BRIEFING NOTE

To:	All Councillors
From:	Simone Plummer, Director Planning
Date:	27 March 2026
Subject:	Monthly Development Assessment Update on <ul style="list-style-type: none"> • State Significant Developments • Housing Delivery Authority • Regional Planning Panel

Inner West Council Response: SSD-82639959

Inner West Council Response: SSD-83721209
Property: 307-315 Parramatta Road, Leichhardt

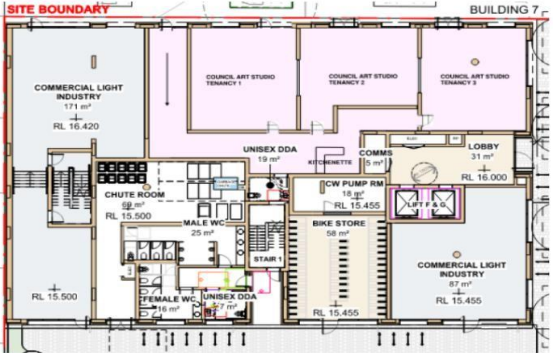
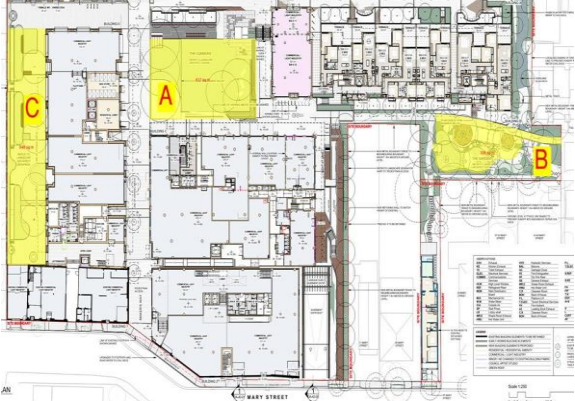
Council's initial response	Applicant's response	Council's follow-up response
<p>Management structure – details of the long-term management of the Artist Studio, potentially through a committee comprising Council representatives, industry leaders, local artists, and Coronation.</p> <p>Input into finishes – Council involvement in the design and fit-out of the Artist Studio to ensure the space is fit-for-purpose and responds to the needs of both the community and local artists. Accordingly, it is recommended that the Department of Planning, Housing and Infrastructure (DPHI) not determine the SSD application until the revised VPA has been negotiated, agreed, and formally secured between Council and the proponent to ensure that the public benefit reflects the increased scale of development proposed.</p>	<ul style="list-style-type: none"> • The Council Art Studio is to be increased from 239m2 to 250m2. • Council will be offered long-term management of the Council Art Studio as identified in blue in Figure 18 below. • Council will have input into fit-out works, including the partition into individual studios, to ensure that it responds to the needs of both the community and local artists. <p>Furthermore, it is worth highlighting that amendments to the VPA under SSD 82639959 will provide the following additional benefits to Council when compared to DA/2021/0800:</p> <ul style="list-style-type: none"> • Delivery of additional public open space, representing an increase of 55% under the VPA, including: <ul style="list-style-type: none"> ○ The Garden – increase from VPA of 250sqm to approx. 300sqm (Area B in Figure 19). ○ The Mews – 0sqm required by VPA to approx. 650sqm (Area C in Figure 19). ○ The Commons – retained at 600sqm per VPA (Area A in Figure 19).

Figure 2. Indicative envelope of Hay Street Carpark Site

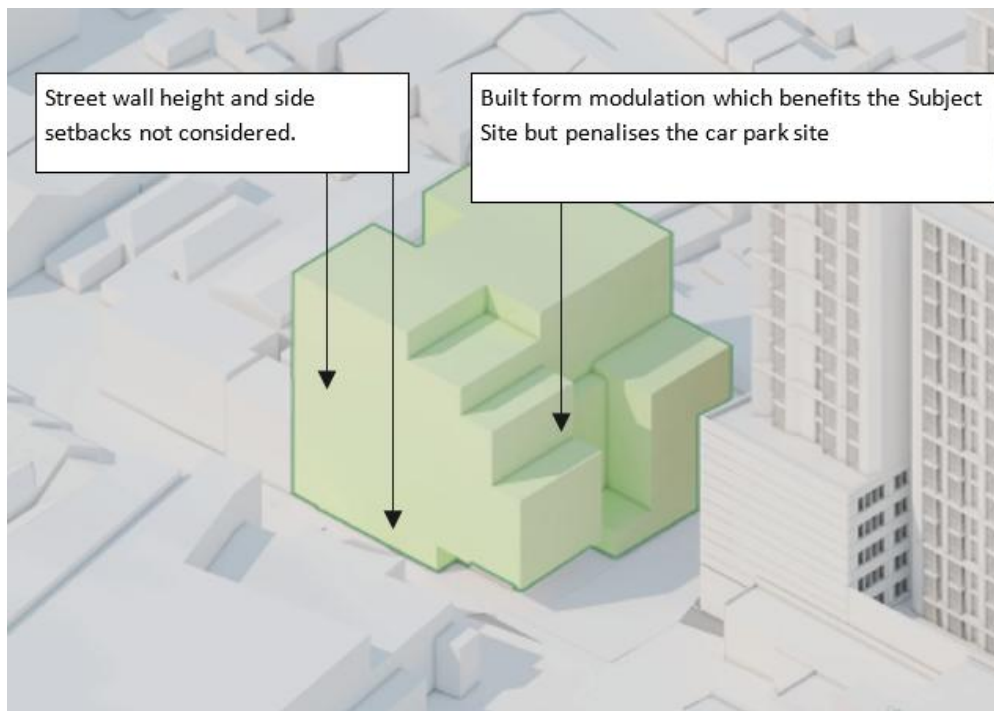
proposed massing would result in burdening Council-owned site to provide additional setbacks, which should be equally distributed between the sites. It also fails to consider key site-specific controls, including required upper-level setbacks to Hay Street and side setbacks to the northern boundary.

Overall, the SSD proposal fails to account for the full redevelopment capacity of adjacent sites and does not demonstrate how overshadowing, solar access and built form impacts from a compliant redevelopment would be accommodated in its design.

Figure 4. Proposed building setbacks and separation and non-compliance tower form

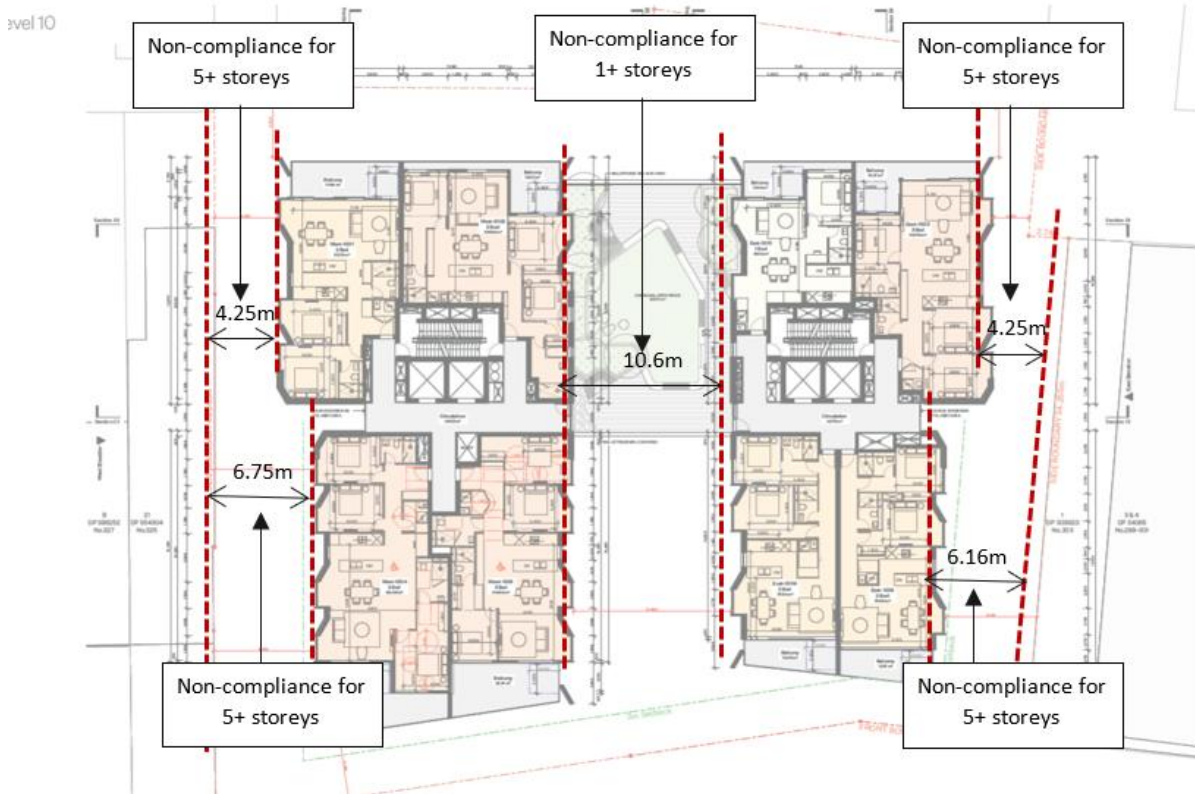
- The proposed side setbacks (4.25m and 6.1–6.8m) for the tower components do not comply with ADG requirements, which requires:
 - Minimum 6m setbacks for 5–8 storeys, and
 - Minimum 12m setbacks for 9+ storeys where habitable rooms face each other.
- The proposed 10.6m tower separation is also significantly below ADG minimums, which require:
 - 12m separation up to 4 storeys,
 - 18m for 5–8 storeys, and
 - 24m for 9+ storeys between habitable rooms.
- Although the design uses reeded glazing to mitigate privacy impacts, this does not address the fundamental non-compliances with setbacks and separation and is not considered to be an acceptable design response.
- Increased setbacks with single storey tower form will assist with meeting ADG requirements.

Figure 6. Applicant's indication of a future land dedication for public road shown in red shaded area for the northern laneway, Appendix 7 Urban Design Report (page 67)

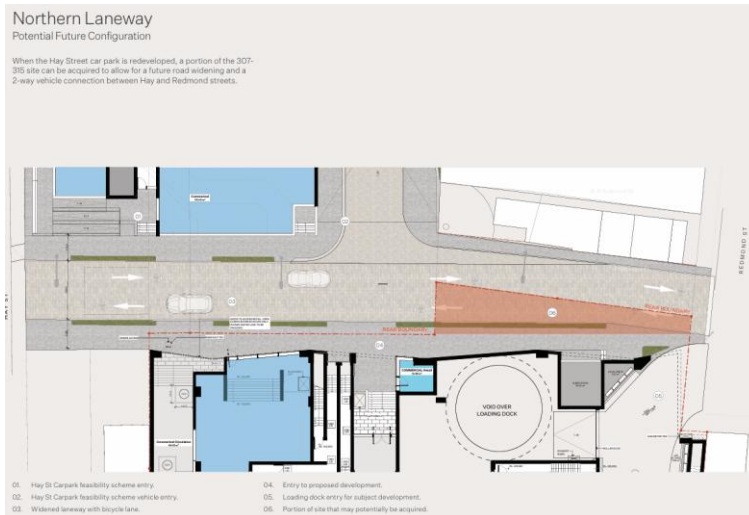
- Reference is drawn to page 67 to Appendix 7 of the Urban Design Report, in particular the statement that “When the Hay Street car park is redeveloped, a portion of the 307-315 site can be acquired to allow for future road widening and a 2-way vehicle connection between Hay and Redmond Street”. The diagram accompanying the statement is provided below, noting the red shaded area as the applicant’s earmarked future land dedication area. The future land dedication is also stated on page 14 of Appendix 10 Stormwater Plans. The applicant’s statements acknowledges that road dedication is required to facilitate the surrounding lots’ redevelopment.

Figure 7. Land to be dedicated to Council to accommodate 9m wide laneway reserve between Redmond Street and Hay Street.

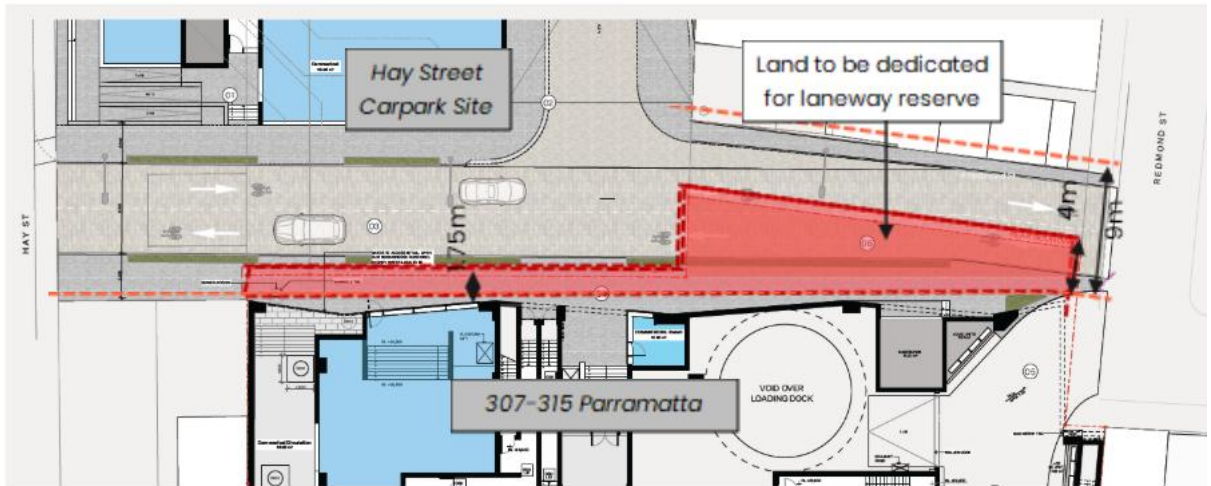
- A minimum width of 9m is required to facilitate the cycleway/shared zone connection. This means that a minimum 4m wide dedication from the northeast portion of the site is required.

- This will allow this laneway to continue along Redmond St which is also currently 9m wide.

- The proposal must dedicate this land to facilitate the public domain improvements. The design should also be amended, including siting of the development and access, and extent of the basement encroachment, consistent with Council’s aspirations.
